THE CITY OF KEY WEST PLANNING BOARD
Staff Report

Application: **Major Development Plan – 700-724 Truman Avenue (RE #00030020-000000)** – A request for approval of a Major Development Plan and Landscape Waivers to renovate an existing building and convert approximately 15,187.21 SF of space into a high school on a parcel located within the Historic Public and Semi-public Services (HPS) zoning district pursuant to Section 108-91.A.2 and Section 108-517 of the Land Development Regulations of the Code of Ordinances of the City of Key West.

Rendering of auditorium building converted to a high school, submitted by the Applicant.

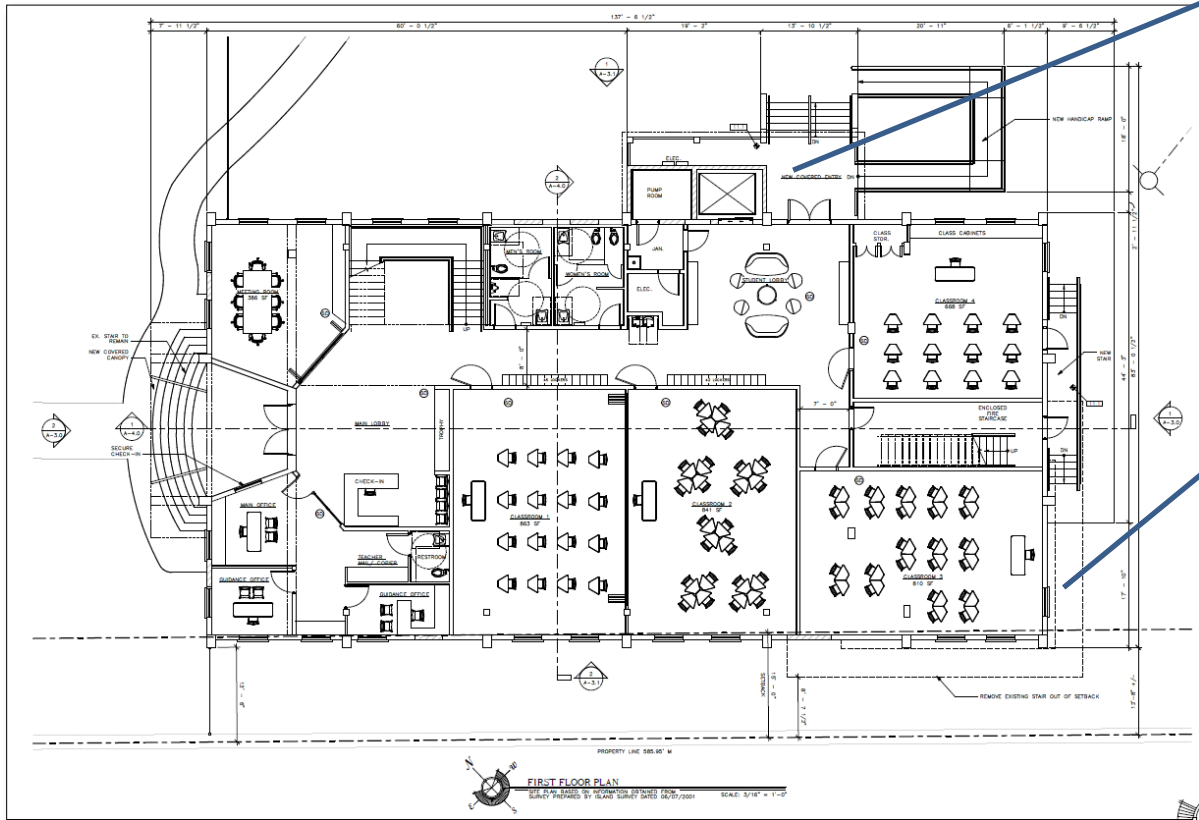
New covered entry

Removal of external stair case
